WIDEFIELD WATER AND SANITATION DISTRICT - BOOSTER 2 PUMP STATION
COUNTY OF EL PASO, STATE OF COLORADO
GRADING & EROSION CONTROL PLANS

PPR-21-069

WWS BOOSTER 2 PUMP STATION

FINAL GRADING / EROSION CONTROL PLAN

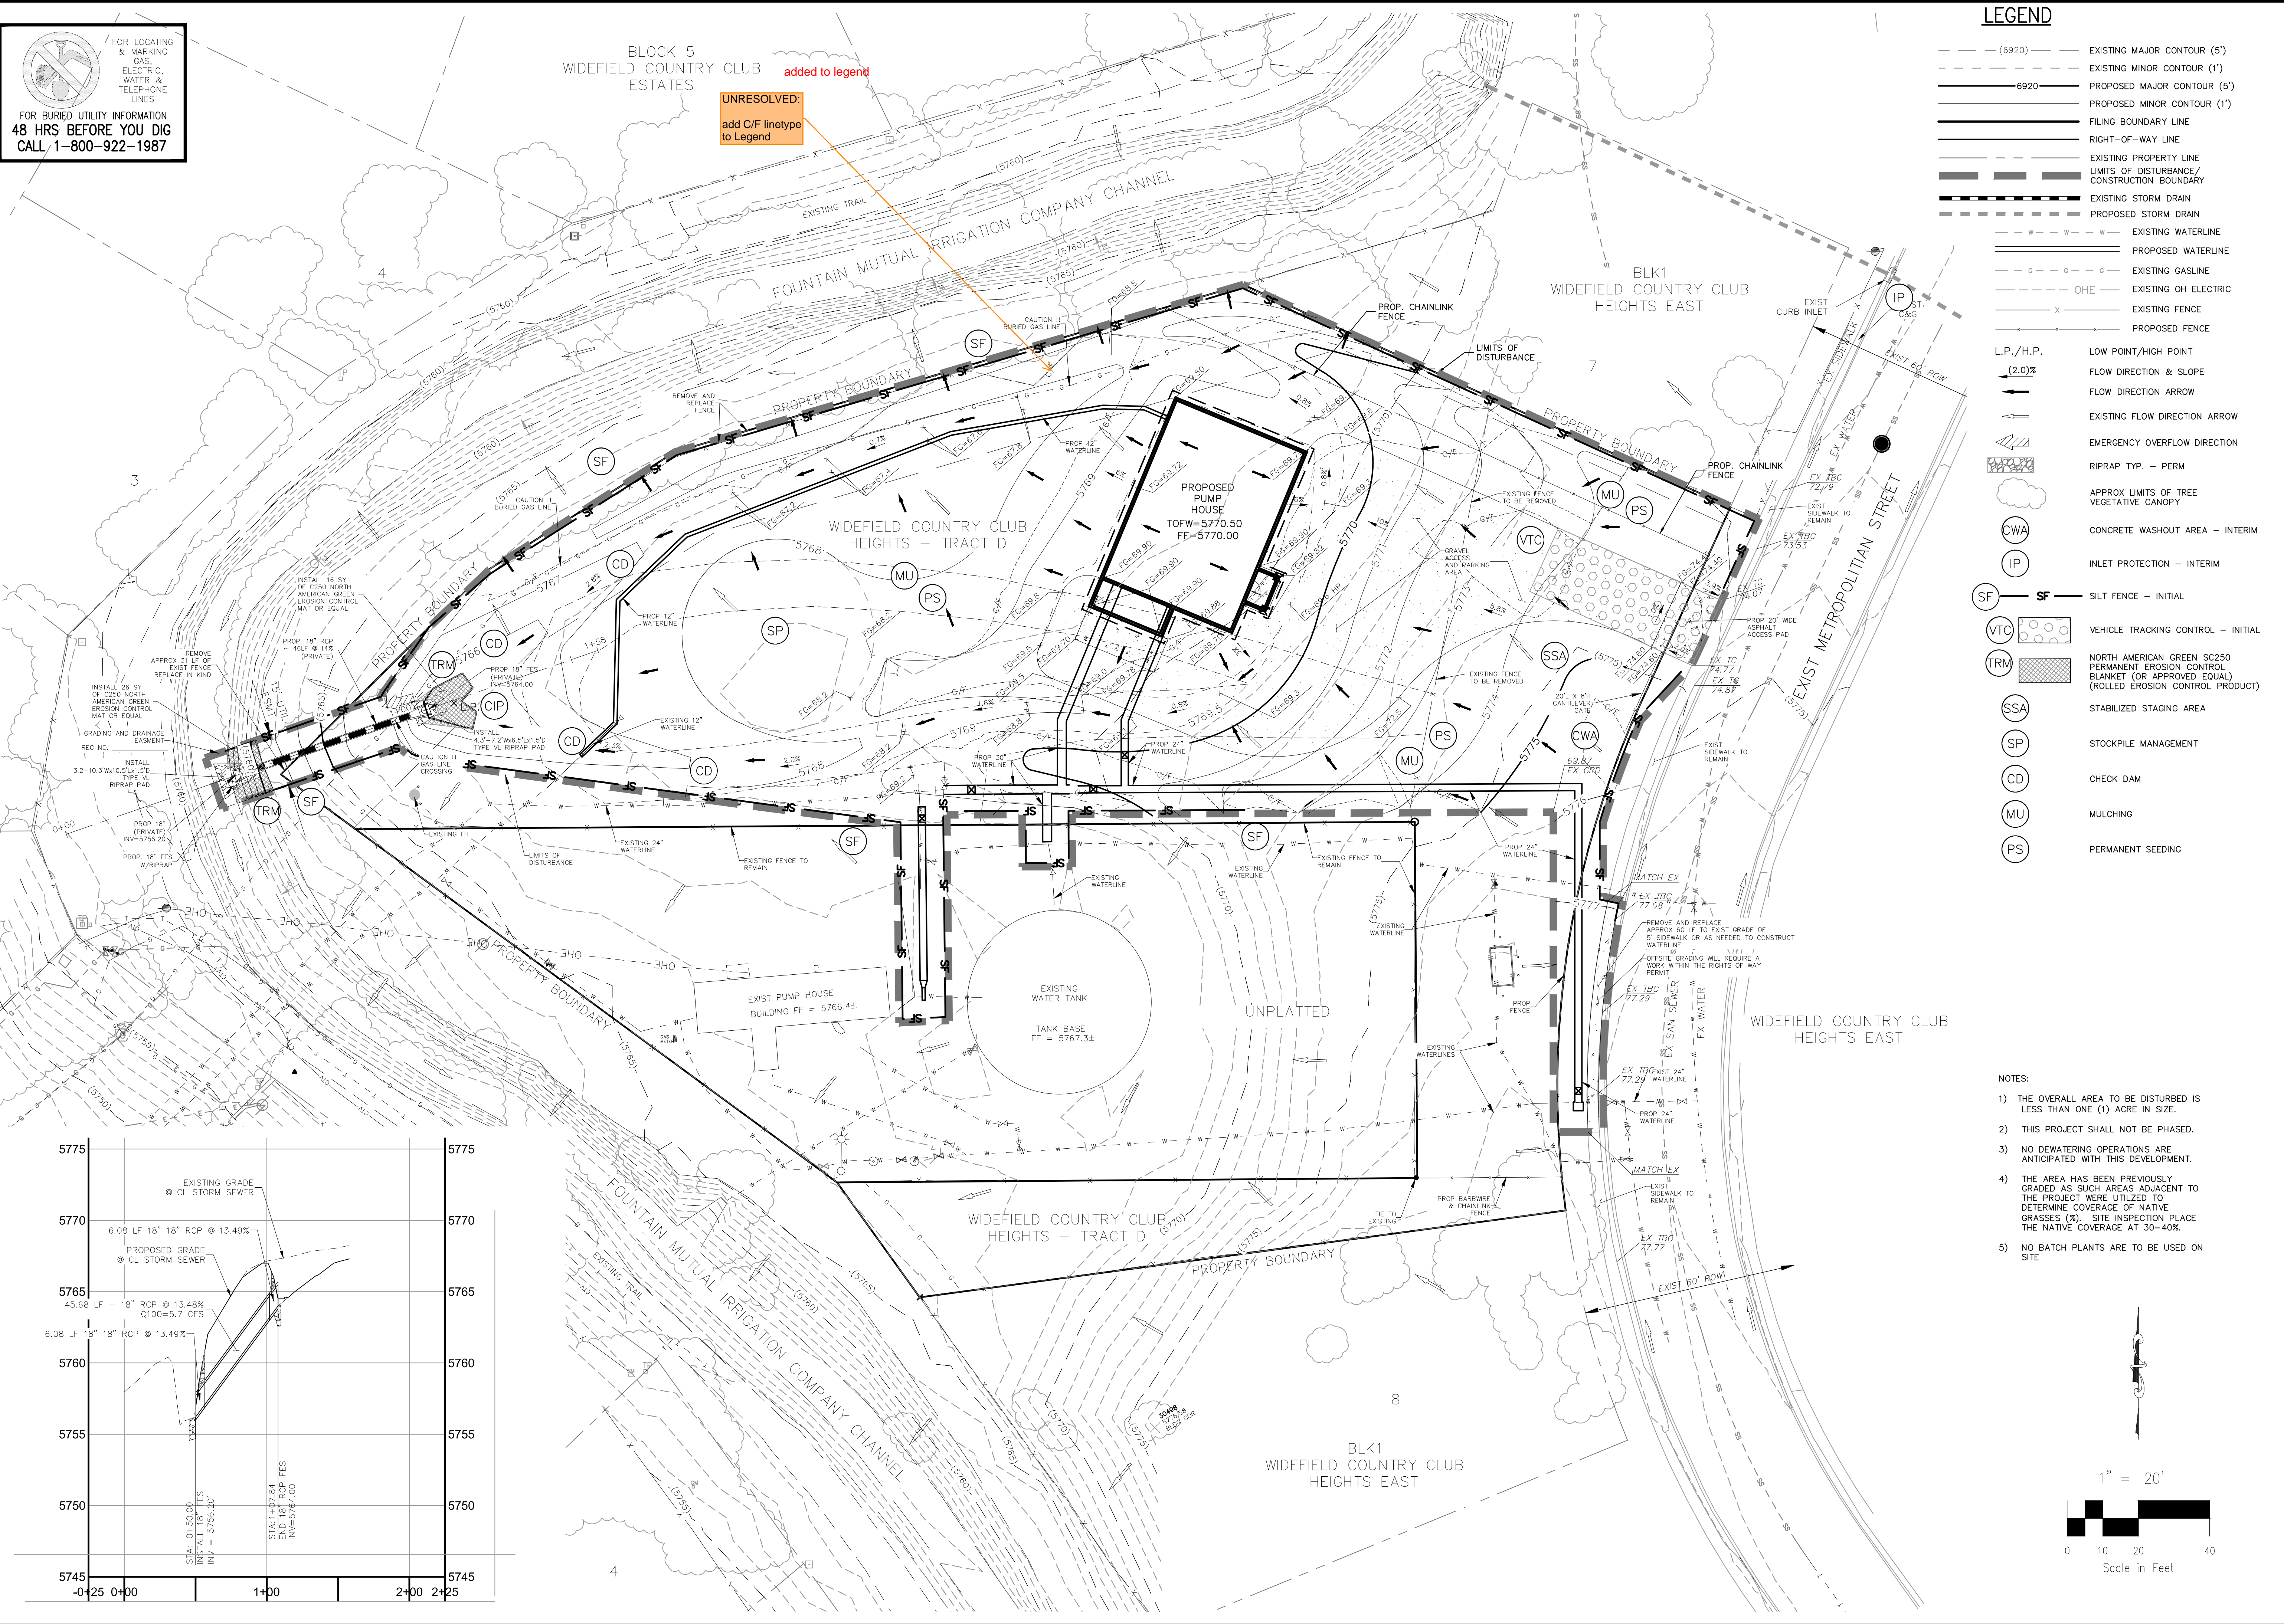
UNRESOLVED:
add C/F linetype
to Legend
